**Public Comments Regarding the
EPA Region 8 Proposed Dewey-
Burdock In-Situ Uranium Recovery
Project Permitting Actions**
Comments from Named Entities

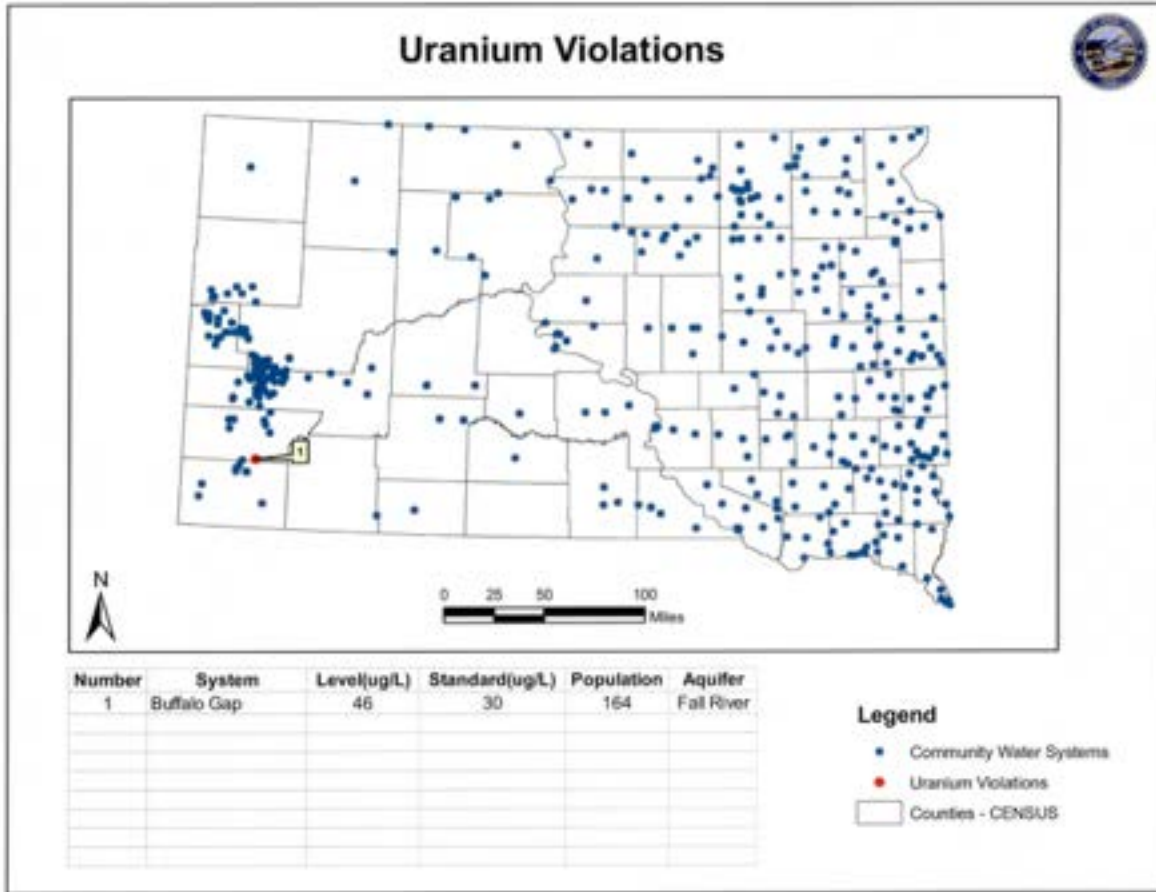
Two Options for AE Approval: For this reason, the EPA is offering and requesting comment on two options for approval of the AE area based on the status of well 16:

Option 1 includes approval of the AE area shown in Figure 4, excluding the two Burdock Area wellfields (6 and 7) shown in blue in Figure 4. Powertech may request the exemption of Burdock wellfields 6 and 7 once well 16 is plugged and abandoned after the alternative water supply is in place. Both Burdock wellfields 6 and 7 are being excluded from this option because it appears that the southeastern end of Burdock wellfield 7 partially overlaps the northeast end of Burdock wellfield 6 in the area of well 16 as shown in Figure 4. Well 16 is located up-gradient of Burdock wellfields 1 and 8, which are the closest Burdock wellfields to well 16 outside of wellfields 6 and 7. Even though well 16 is located up-gradient of Burdock wellfields 1 and 8, the EPA calculated the capture zone width for well 16, as discussed below, to verify it does not cross the AE boundaries for Burdock wellfields 1 and 8.

Option 2 allows Powertech to plug and abandon well 16 before the issuance of the final AE Record of Decision. After well 16 has been plugged and abandoned, the EPA will be in a position to determine that the groundwater within the AE boundary for Burdock wellfields 6 and 7 is not a current source of drinking water, and can approve the portion of the AE area shown in blue in Figure 4 as part of the final AE Record of Decision.

Figure 2. Location of the Study Area, which includes the Dewey-Burdock Project Area and a 20-mile buffer measured from the approximate Project Area Boundary, and the Edgemont Area, which includes a 5-mile buffer around the City of Edgemont.

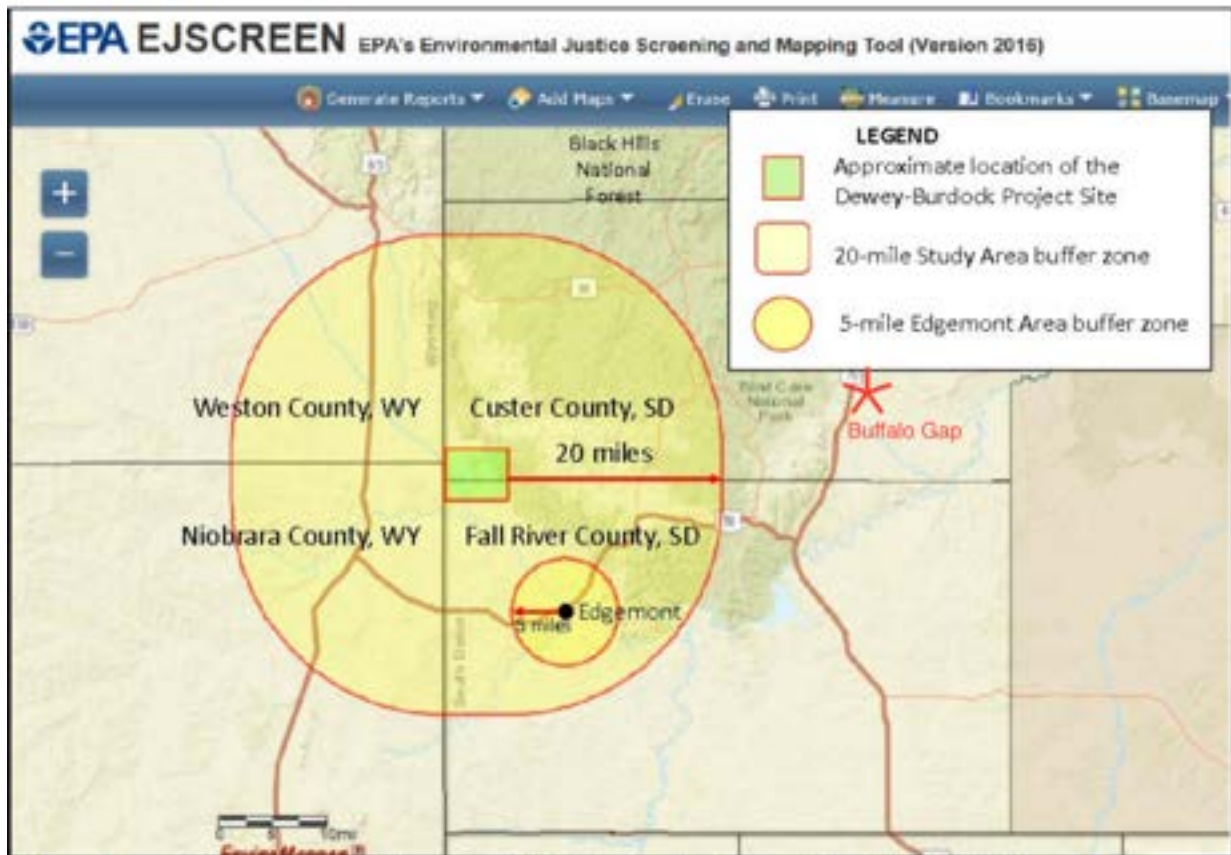
Section 1.3 of the EJ Analysis states that the EPA used a 20-mile buffer zone measured from the location of the Dewey-Burdock Project Area Boundary without considering the flows of water or related aquifers that impact areas farther away such as Buffalo Gap, SD. The EPA found that ‘Based on the preliminary screening processes, the City of Edgemont, South Dakota was identified as a community for which the EPA should conduct additional evaluation to determine if the area is a potentially overburdened community as discussed in Section 2.5.’

The Town of Buffalo Gap, SD, shown in close proximity to the Project Area Boundary, should be included in the EJ Analysis. Like Edgemont, SD, the Town of Buffalo Gap, SD, is a potentially overburdened community.

Figure 70. Subareas, generalized ground-water flow directions, and flow zones for the Minnelusa aquifer. Estimated transmissivities and flow components for flow zones also are shown (from Carter, Driscoll, Hamade, and Jarrell, 2001).

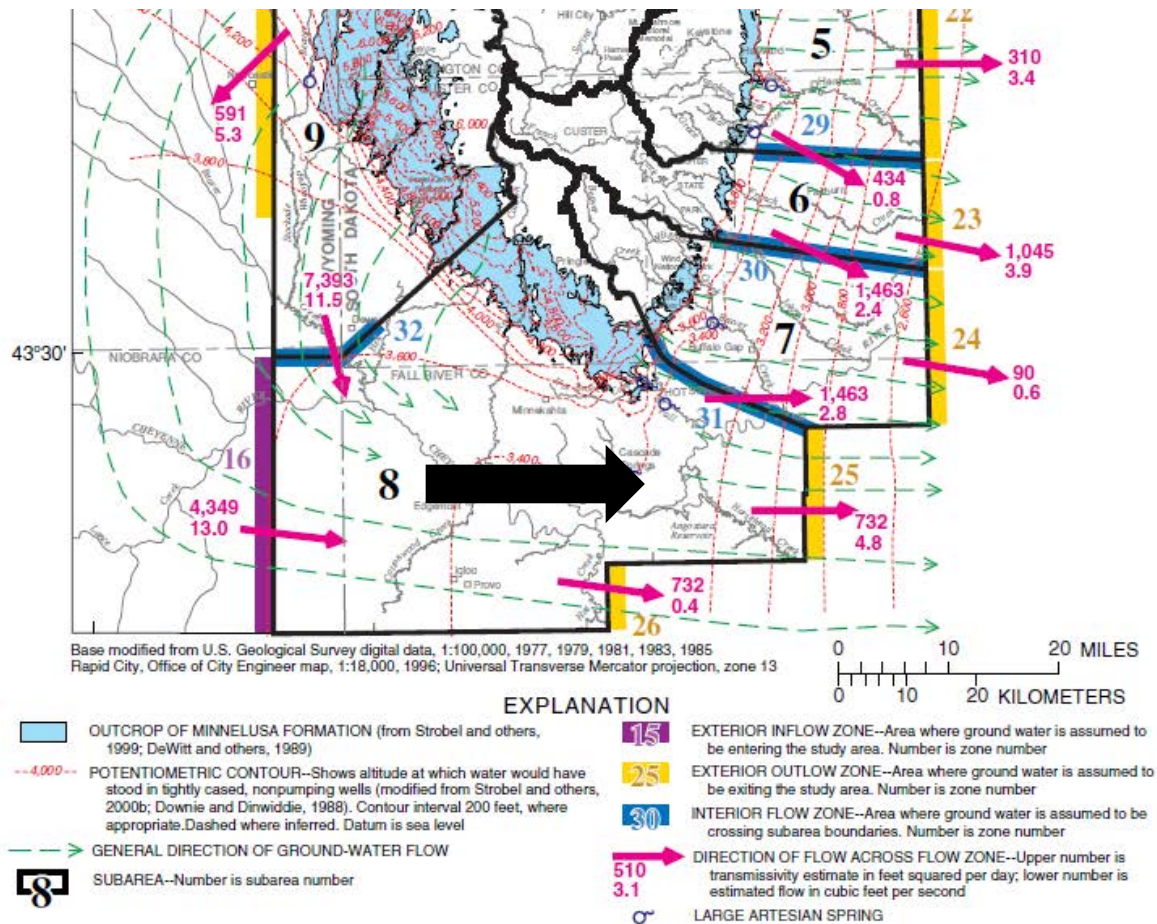
Figure 70 shows that while groundwater flow north of Dewey-Burdock may initially be to the SW into Wyoming, this flow path quickly corrects to southward and then eastward flow. The flow from north of Dewey-Burdock to the SW has been measured at 591 feet/day, but flow south of the site has been measured at 7,393 feet/day. Once eastward flow is established, its been measured at 4,349 feet/day to the east at the SD-WY state line, then 1,463 feet/day to the east in northern Fall River County and 732 feet/day to the east in central and southern Fall River County. On average, flow from Dewey-Burdock towards Edgemont, Hot Springs, Buffalo Gap,

Figure A3-1. Dewey Wellfield 1 Potential Post-Restoration Groundwater Monitoring Wells.

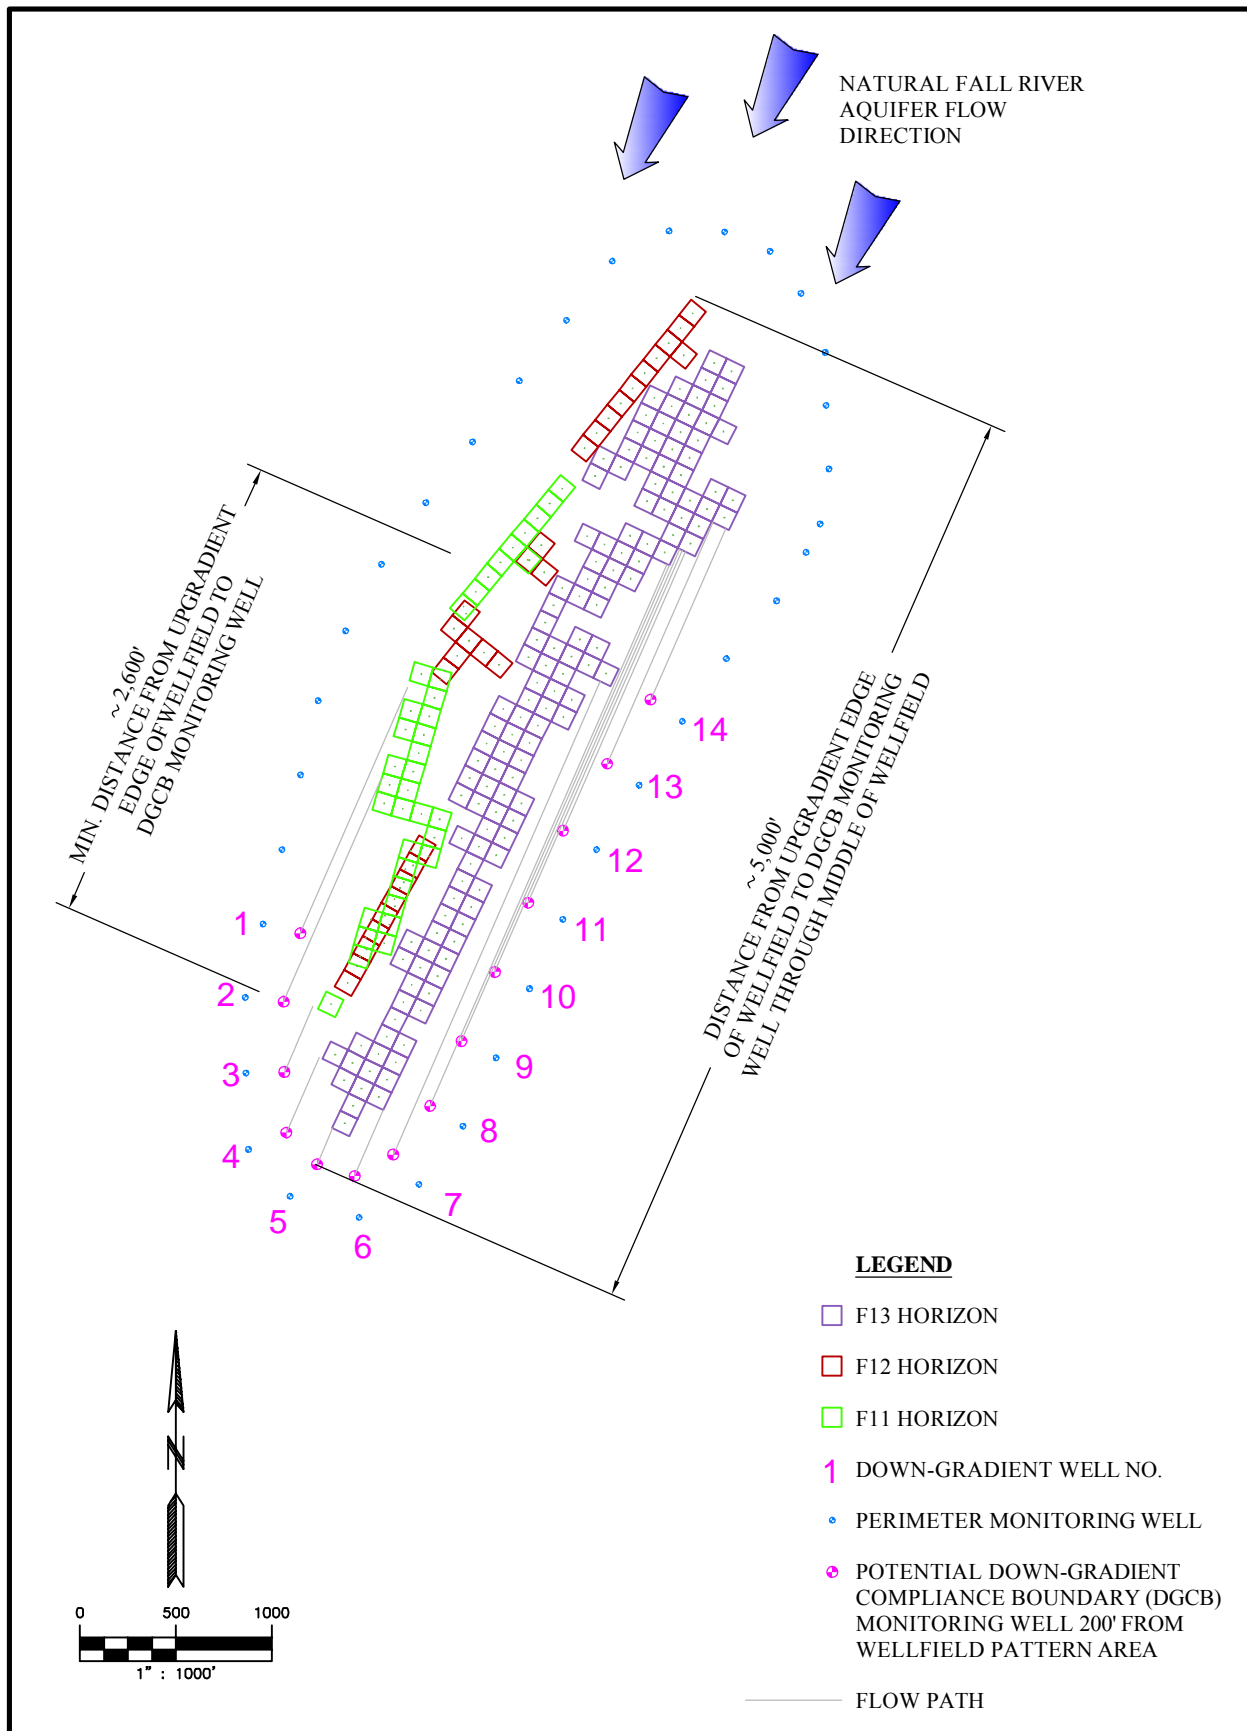
Figure A3-1 shows the approximate configuration of Dewey Wellfield 1, as depicted in Plate 7.1 of the Class III permit application, along with the natural groundwater flow direction from Figure 5.2 in the Class III permit application. This figure shows that the natural groundwater

gradient closely follows the longitudinal wellfield axis, much more so than what is depicted in Figure B4 in the Draft Class III Area Permit. The result is that the distance along the natural groundwater flow path between the wellfield and potential DGCB monitoring wells is much farther than the offset distance of the DGCB wells from the wellfield. This is illustrated in Table A3-1, which compares the distance along the natural groundwater flow path from the down-gradient edge of the wellfield to potential DGCB monitoring wells placed either 200 or 400 feet from the wellfield. The distance of groundwater travel ranges from 200 to 3,078 feet for wells placed 200 feet from the pattern area and 400 to 3,570 feet for wells placed 400 feet from the pattern area. Based on the average Fall River groundwater flow velocity of 6.1 feet per year, from Appendix 6.1-A (numerical groundwater flow model) of the approved NRC license application (Exhibit 018 at p. 6.1-A-11), it would take 33 to 505 years for groundwater to reach DGCB monitoring wells placed 200 feet from the wellfield or 66 to 585 years to reach wells placed 400 feet from the wellfield. Since the draft permit would require verification that the tracer reaches each DGCB monitoring well, it would be necessary to wait at least 500 years for groundwater to reach the most distant wells under natural groundwater flow conditions.

Given that Dewey Wellfield 1 would be about 4,700 feet long, the travel time from the upgradient edge of the wellfield to potential DGCB monitoring wells would be hundreds of years for any well. Figure A3-1 shows that the minimum distance would occur for potential DGCB monitoring well location 2, southwest of the wellfield. Even this minimum distance is more than 2,600 feet, corresponding to a travel time of 400 to 500 years. If it were necessary to inject a
